LUFTDYKTIGHETSPÅBUD (LDP)

97-091 KONTROLL AV HOVEDROTOR «TRANSMISSION RING GEAR»

97-23-06 SCHWEIZER AIRCRAFT CORPORATION: Amendment 39-10194. Docket No. 96-SW-05-AD.

2001-25-52 SCHWEIZER AIRCRAFT CORPORATION: Docket No. 2001-SW-58-AD. Supersedes 76-18-01, Amendment No. 39-2707, Docket No. 72-WE-23-AD.

Figure 1

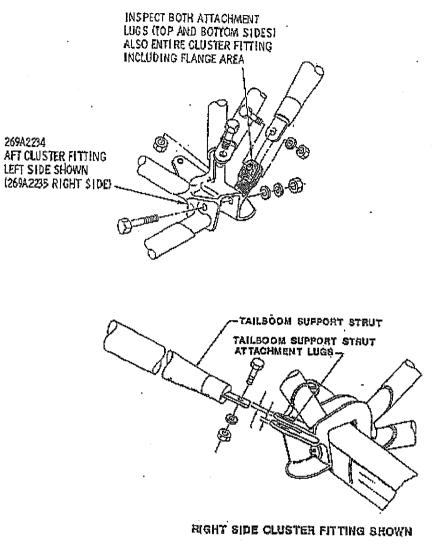
To prevent failure of a strut clevis lug (lug) on a center frame aft cluster fitting (cluster fitting), rotation of a tailboom into the main rotor blades, and subsequent loss of control of the helicopter, accomplish the following:

(a) Within 10 hours time-in-service (TIS), and thereafter at intervals not to exceed 50 hours TIS, for helicopters with cluster fittings, P/N 269A2234 or 269A2235:

(1) Using paint remover, remove paint from the lugs on each aft cluster fitting. Wash with water and dry.

(2) Dye-penetrant inspect the lugs on each aft cluster fitting. See Figure 1.

(3) If a crack is found, before further flight, replace the cracked cluster fitting with an airworthy cluster fitting. Cluster fittings, P/N 269A2234 and 269A2235, are not eligible to replace a cracked cluster fitting.
